16 William St.

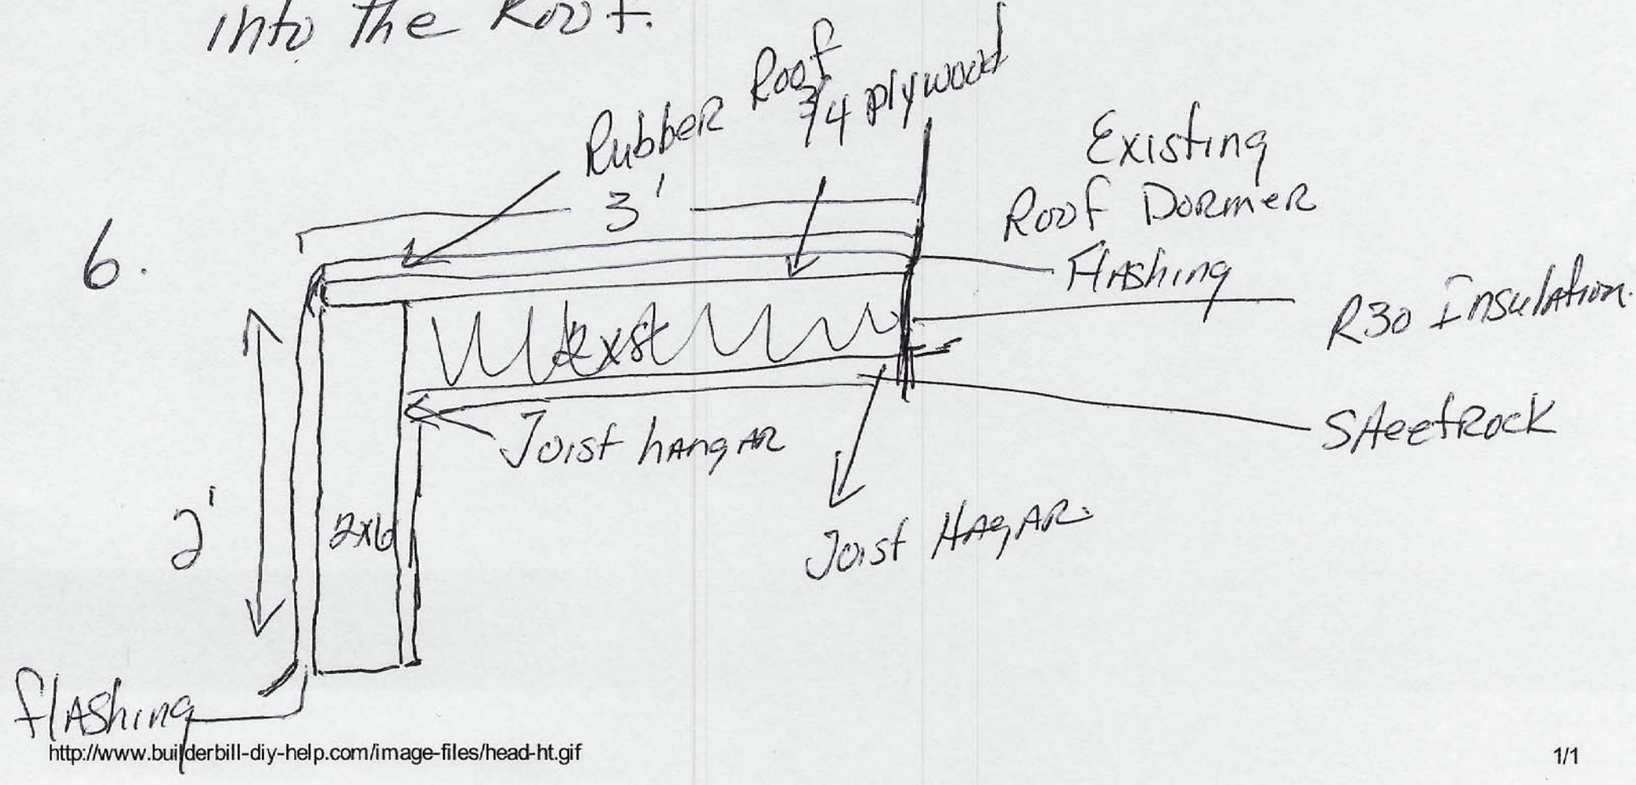
Existing / Remove and add.

1. Added (3) 2x6 Ceiling Joists 16" o.c.
2. Added 2' WALL to RAISE height of the ceiling 16" O.C. 2x6
3. 3/4 Plywood Roof sheathing
   A.) Rubber Roof
4. R30 ~~Insulation~~ then Sheetrock 1/2

Added height to Roof to get head height for stairs.

5. Rubber Roofed WALL with flashing tieing into the Roof.
